# SERVICE INSTRUCTION

## INTRODUCTION OF A NEW AIRBOX PART NO. 667167

### FOR ROTAX® ENGINE TYPE 914 (SERIES)

### SI-914-015

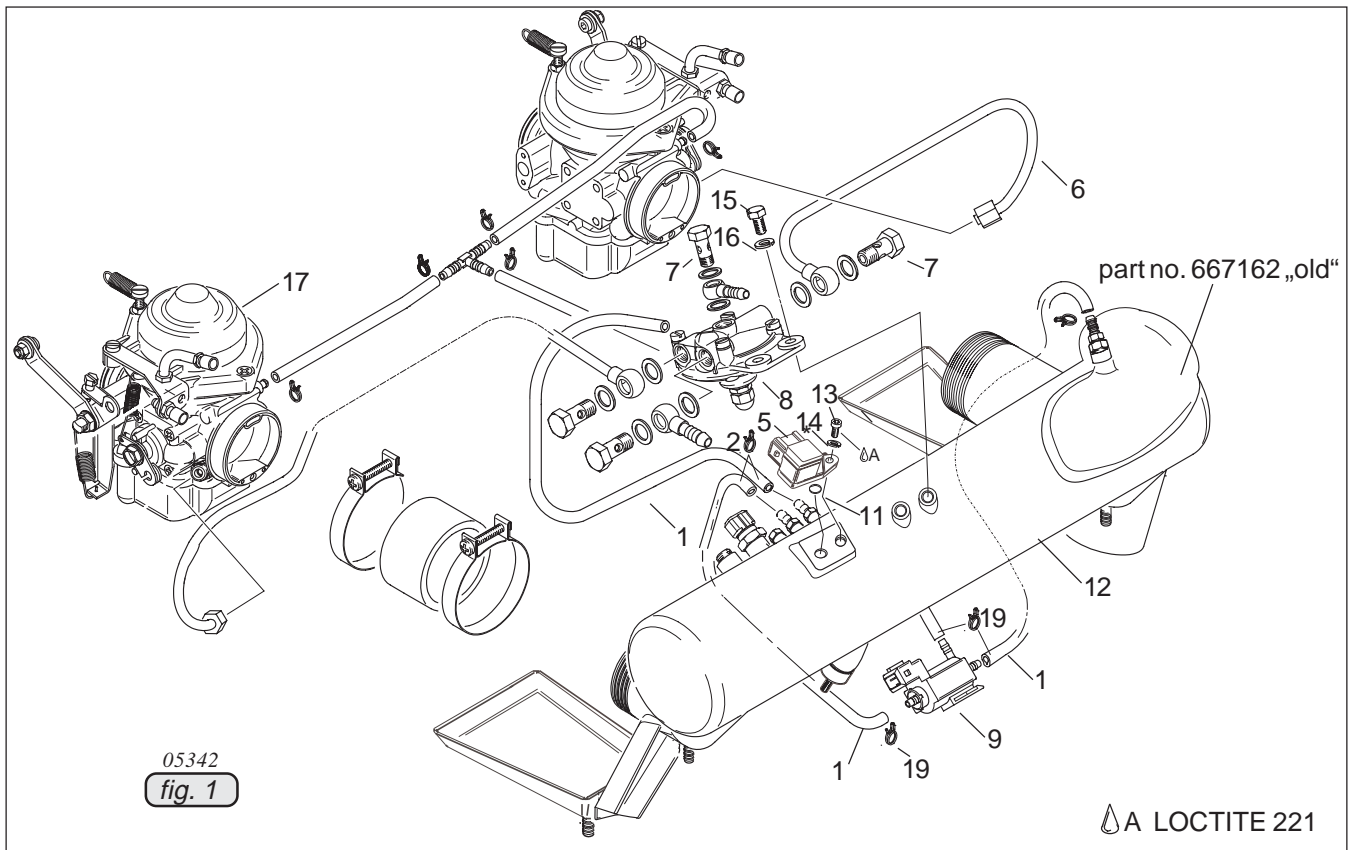
(See fig. 1)

- Remove connecting line of pressure sensor (5).
- Dismantle pressure connections (1) and clamps (2)(19) and pressure sensor (5).
- Disconnect fuel lines (6) by removing banjo bolts (7) of fuel-pressure regulator (8).
- Remove fuel-pressure regulator (8) from airbox.
- Remove airbox.

00033  
fig. 2

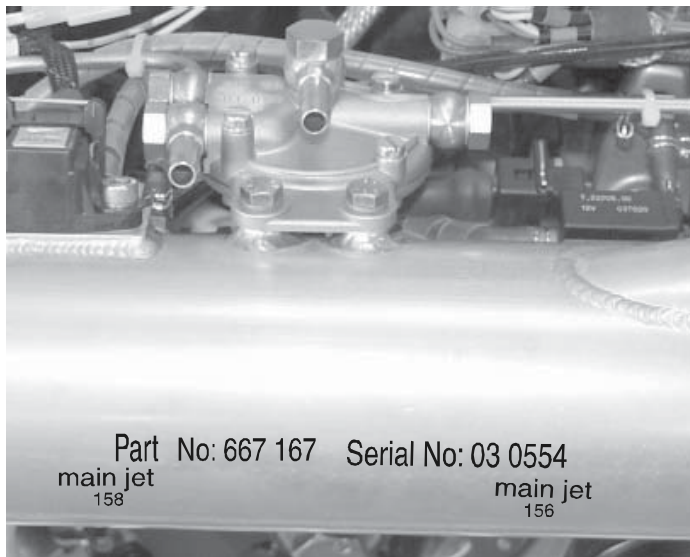
(See fig. 2)

- Adjust the 1/3 cylinder side carburetor nozzle-needle to position 2 and carburetor 2/4 to position 2 as per currently valid Maintenance Manual 914 F.

■ **CAUTION:** The above mentioned nozzle-needle position is the basic setting for airbox part no. 667167.

05764  
fig. 3

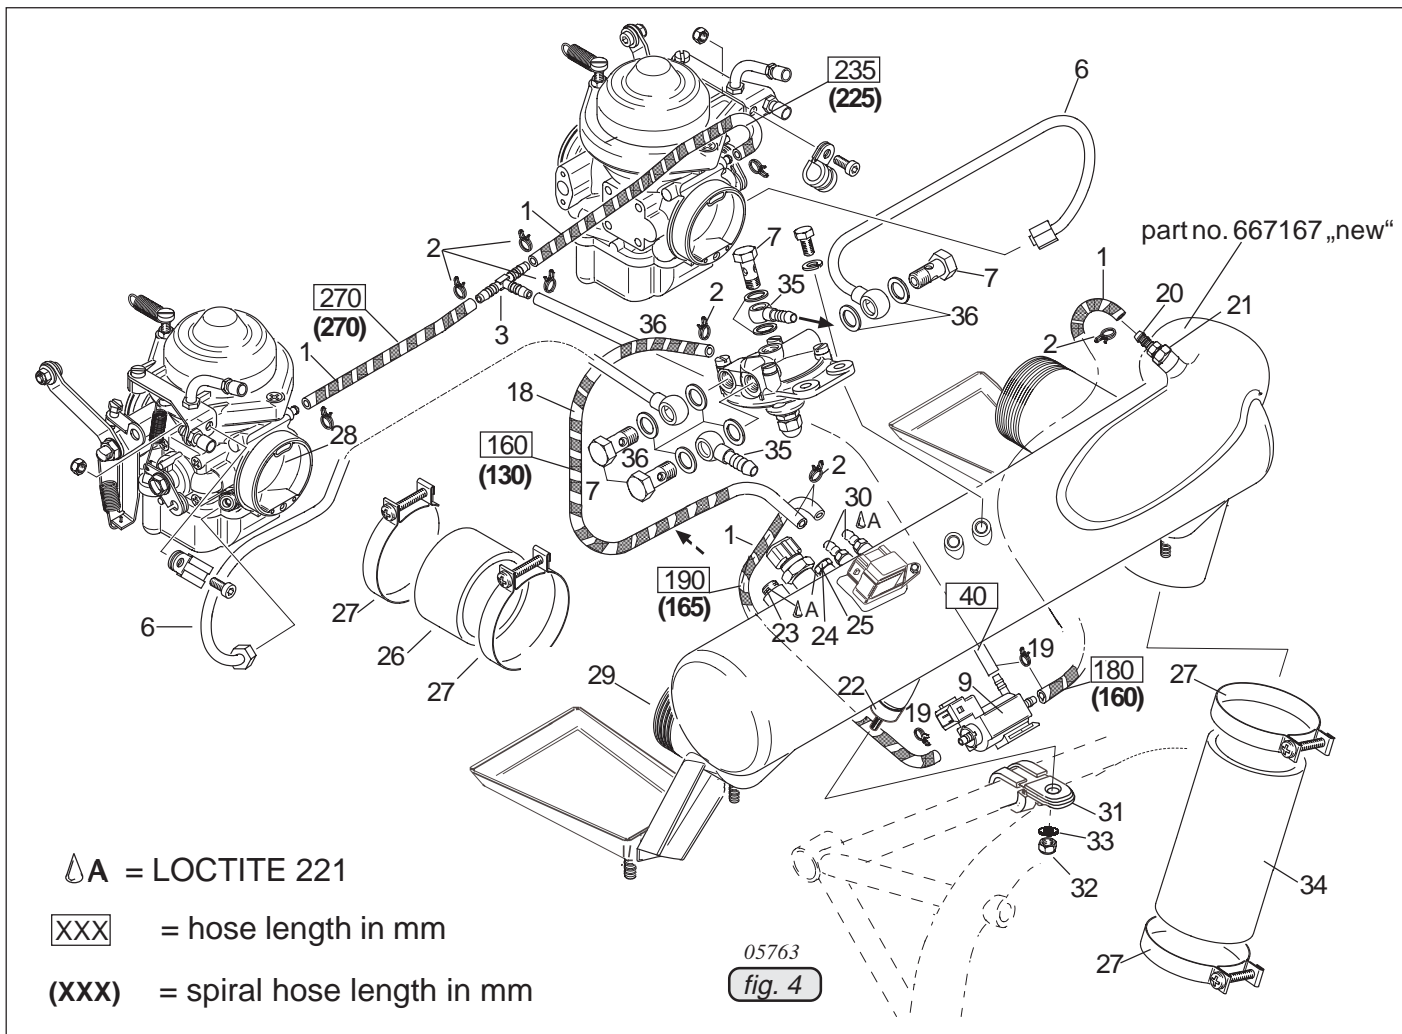
(See fig. 3)

Laser marking of the airbox with indication of the respective main jet of the relevant carburetor.

Identification of the new  
airbox:  
- part no.  
- serial No.  
- 2x amount of main jet

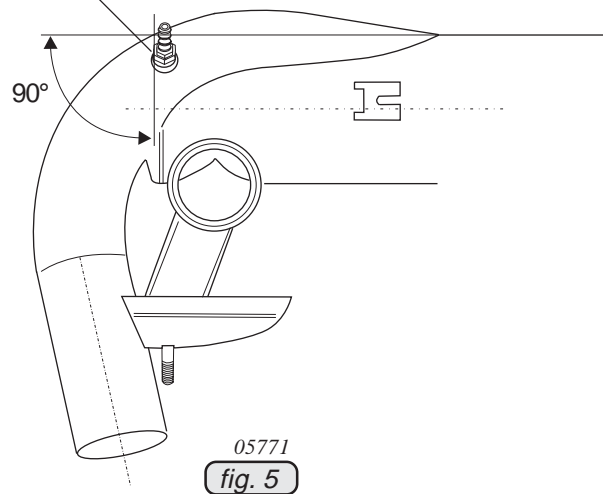
■ CAUTION: The counter sinking on the hexagon must stand perpendicular to the airbox (see fig. 5).

Position of the enrichment jet:  
counter sinking on the hexagon
